SERVICE BULLETIN

Service Bulletin No.: DA20-31-02 Rev 1

Title: Hourmeter, Engine Activated Installation

FIGURE 1

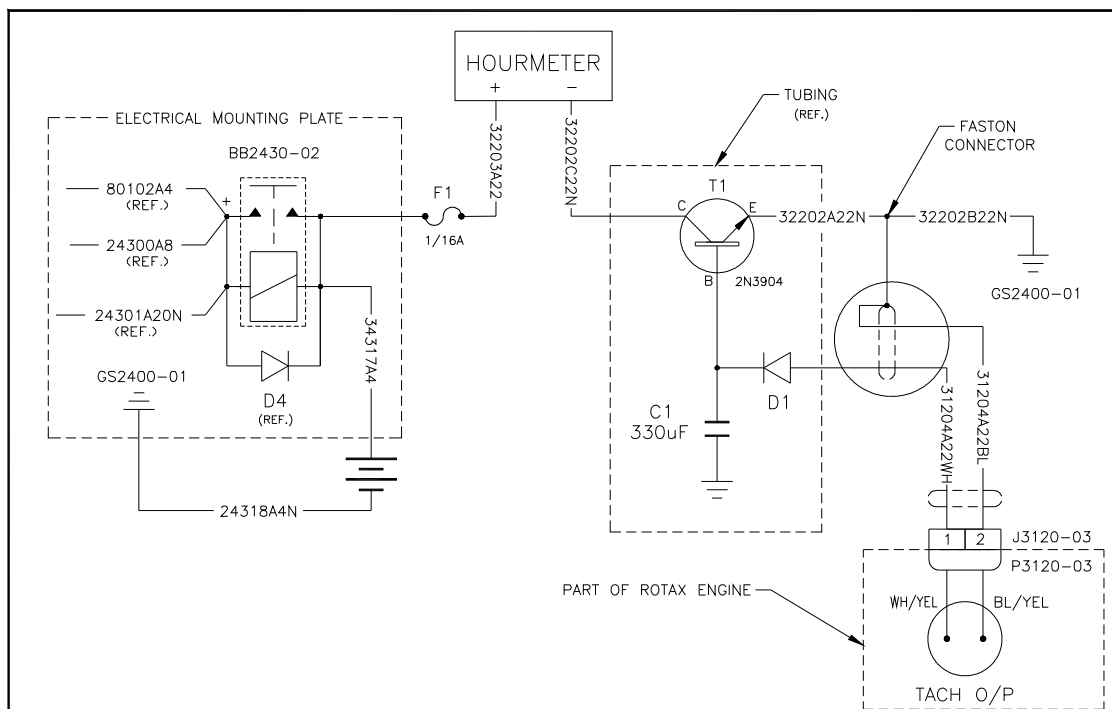
3. **General:** The existing Hourmeter is activated when electrical power is applied with the master switch. This new version is activated by the engine and cannot be switched off from the cockpit.

11.1.3 Disconnect wire No. 32203A22 from Hobbs Meter and Fuel Pump C/B and discard.

- 11.1.4 Disconnect wire No.32202A22N from Hobbs and plug into wire No.32202B22N and wire No.31204A22sh Faston.
- 11.1.5 Ty-Rap assembly behind gauges.
- 11.1.6 Attach wire No. 32203C22N to the Hobbs (-) Terminal and the new 32203A22 to Hobbs (+) Terminal.

- 11.1.7 Route wire No.31204A22 and wire No.32203A22 through Grommet in Firewall ty-rap as required, route through center of larger gauge wires.
- 11.1.8 Solder the fuse holder cap to the end of wire No.32203A22. Insert the fuse and close the holder.

- 11.1.9 Connect Fuse Holder Ring Terminal To the Battery Terminal on the Battery Relay.
- 11.1.10 Cut wire No.31204A22 to length, label and install connector P/N 1-480319-0 and pins P/N60617-1.

- 11.1.11 Route existing Tach wires from back of engine, label, terminate with 1-480318-0 connector and P/N 60618-1 Sockets and attach to wire No.31204A22.
